## Economic Commission for Europe

### World Forum for Harmonization of Vehicle Regulations

## Proposal for Supplement 5 the 03 series of amendments to UN Regulation No. 129 (Enhanced Child Restraint Systems)

### Submitted by the Working Party on Passive Safety \*

"Figure 1

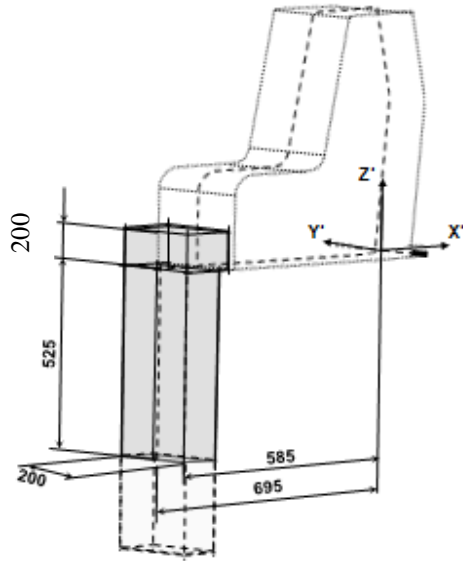
Annex 19, Figure 1 amend to read:

**Side view of the support leg dimension assessment volume**

1. Enhanced Child Restraint Fixture (CRF).
2. ISOFIX low anchorages bar.
3. Plane formed by the bottom surface of the CRF, which is parallel to and 15 mm below the X'-Y' plane of the coordinate system.
4. Z'-Y' plane of the coordinate system.
5. Upper part of the support-leg dimension assessment volume, which shows the dimensional limitations in X' and Y' direction, the upper height limit in Z' direction, as well as the lower height limitation in Z' direction for rigid, not in Z' direction adjustable support leg components.
